**The Fourth Meeting of the Aerodromes Operations and  
Planning Sub-Group (AOP/SG/4)**

**Agenda Item 4: Provision of AOP in the Asia/Pacific Region**  
– **Planning & Design of Aerodromes**

**RUNWAY WITH HOLDING BAYS OR MULTIPLE ENTRANCE TAXIWAYS**

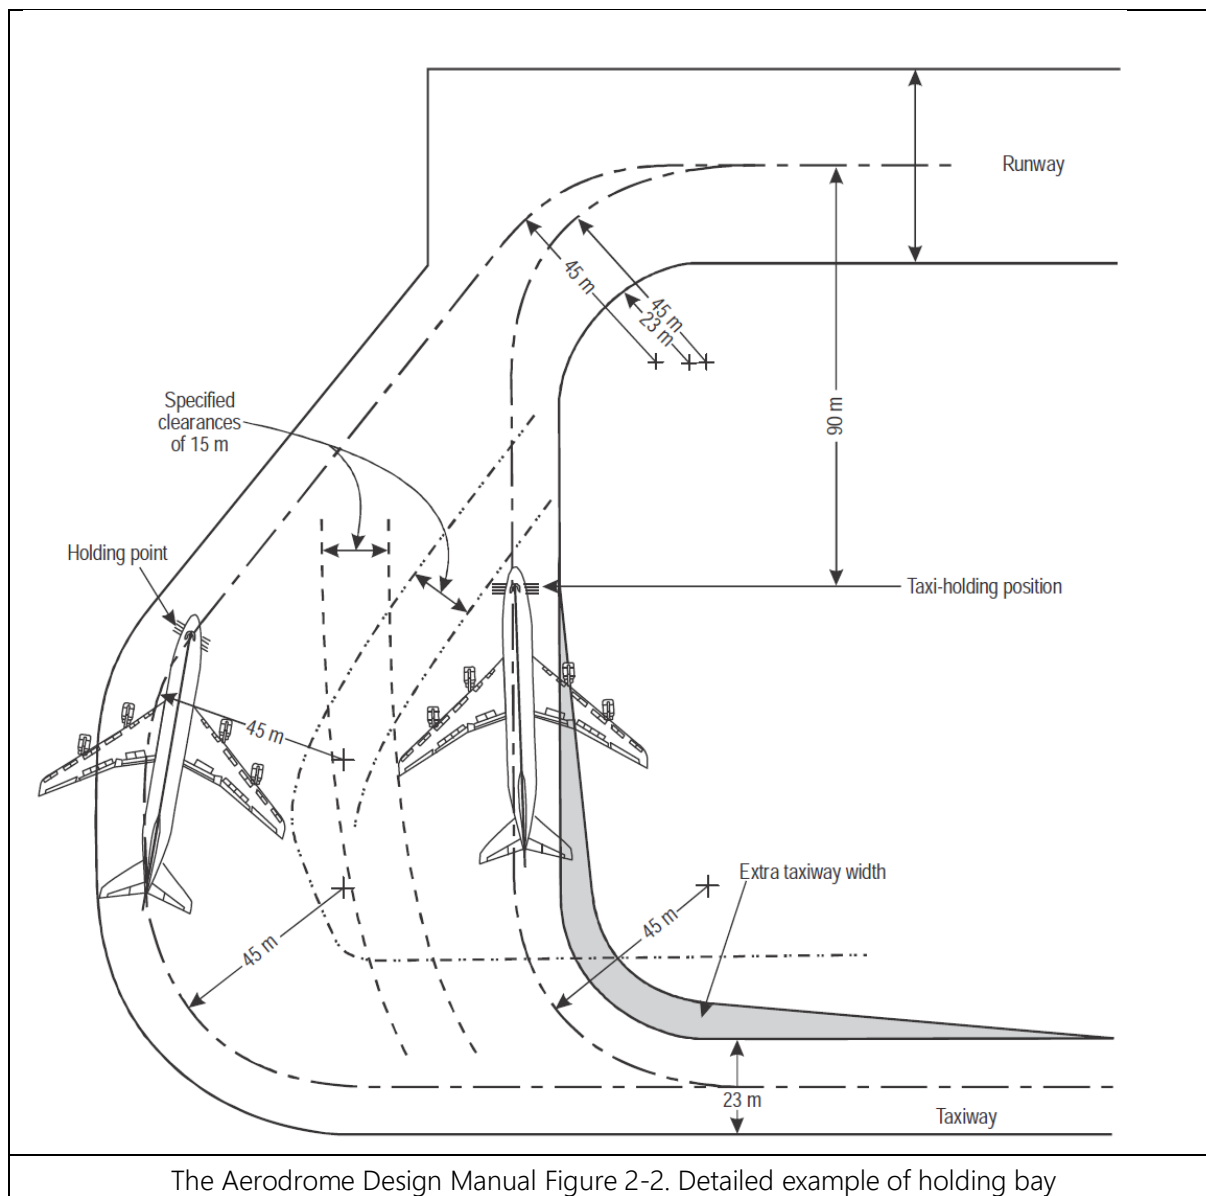
2.1 In ICAO Aerodrome Design Manual Part 2, Figure 2-2, the following issues have been identified. First, in accordance with Annex 14 Volume I, paragraph 5.2.10, the runway-holding position marking shall be marked with double solid lines and double broken lines, with the double solid lines closer to the runway. The total thickness of the runway-holding position marking shall either be 1.05 m or 2.1 m. However, the same marking shown in Aerodrome Design Manual differed from the specification. Second, the locations of aircraft at the holding bays do not meet the regulations. Aircraft cockpit (which will be the location of pilot) straddled on runway-holding position marking (Figure 2-2. Detailed example of holding Bay) will in fact cause runway incursions according to ICAO Manual on the Prevention of Runway Incursions (Doc 9870), and also conflict with actual operations.

<b>Draft Conclusion AOP/SG/4-x: Holding Bays and Multiple Entrance Taxiways</b>	
<p>What: That, the ICAO HQ be invited to consider to:</p> <ul style="list-style-type: none"> <li>a) Review Figure 2-2 of ICAO Airport Design Manual (Doc 9157), Part 2 <i>Taxiways, Aprons and Holding Bays</i> to tally with SARPs of runway-holding position marking and actual aircraft operations; and</li> <li>b) Review the current SARPs in Annex 14, <i>Aerodromes – Volume I, Aerodrome Design and Operations</i> to cater for the design of multiple entrance taxiways.</li> </ul>	<p>Expected impact:</p> <ul style="list-style-type: none"> <li><input checked="" type="checkbox"/> Political / Global</li> <li><input type="checkbox"/> Inter-regional</li> <li><input type="checkbox"/> Economic</li> <li><input type="checkbox"/> Environmental</li> <li><input checked="" type="checkbox"/> Ops/Technical</li> </ul>
<p>Why: To tally a figure in ICAO guidance material with the applicable SARPs and to enhance aircraft safety</p>	<p>Follow-up: <input type="checkbox"/> Required from States</p>

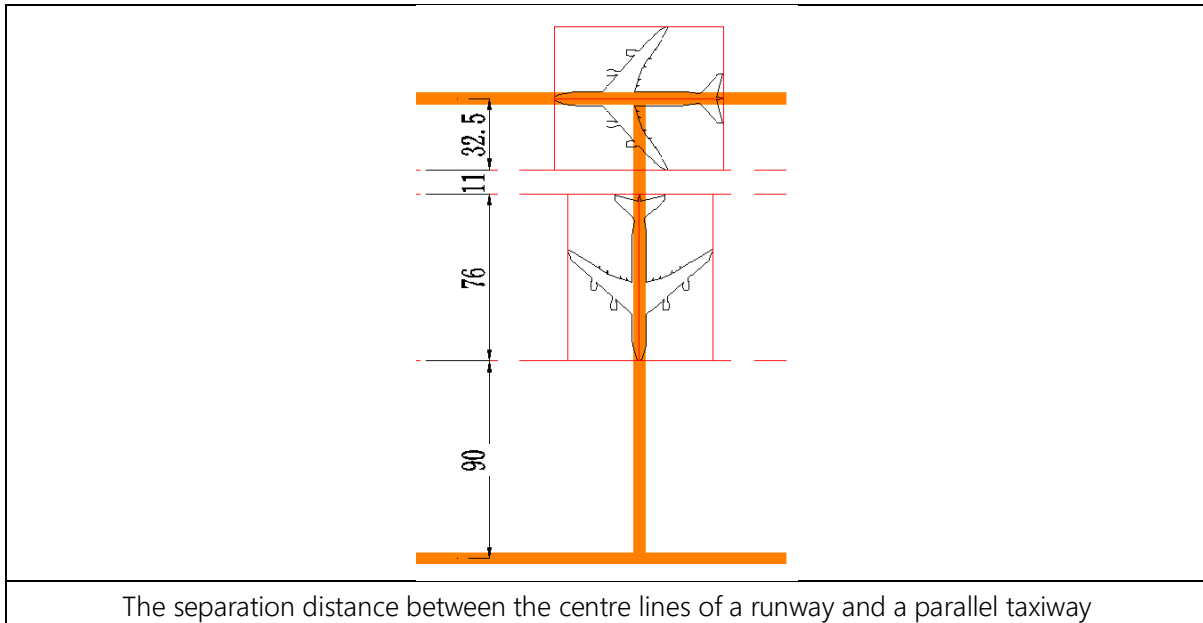
2.2 The Aerodrome Design Manual 1.2.19 states that “The separation distances are based on the concept of the wing of an aircraft centred on a parallel taxiway remaining clear of the associated runway strip. The formulas and separation distances are shown in Table 1-5. The separation distance between the centre lines of a runway and a parallel taxiway is based on the accepted principle that the wing tip of an aeroplane taxiing on the parallel taxiway should not penetrate the associated runway strip. However, this minimum separation distance may not provide adequate length for the link taxiway connecting the parallel taxiway and the runway to permit safe taxiing of another aircraft behind an aircraft holding short of the runway at the holding position. To permit such operations, the parallel taxiway should be so located as to comply with the requirements of Annex 14, Volume I, Tables 3-1 and 3-2, considering the dimensions of the most demanding aeroplane in a given aerodrome code. For example, at a code E aerodrome, this separation would be equal to the sum of the distance of the runway holding position from the runway centre line, plus the overall length of the most demanding aeroplane, and the taxiway-to-object distance specified in column E of Table 1-1.” This is inconsistent with the actual operation. It does not take into account the height of the aircraft, and the pilot's line of sight is greatly restricted. Runway and taxiways lack accurate means of guiding aircraft parking, and lack effective means to make the aircraft head close to the runway-holding position.

2.7 Due to various factors, the aircraft cannot be exactly close to the runway-holding position and wait to stop. This will inevitably cause the tail of the aircraft to enter the wingtip clearance of the aircraft taxiing in parallel taxiways. In fact, it does not meet Annex 14 aircraft distance on taxiways. The provisions of the object spacing standard.
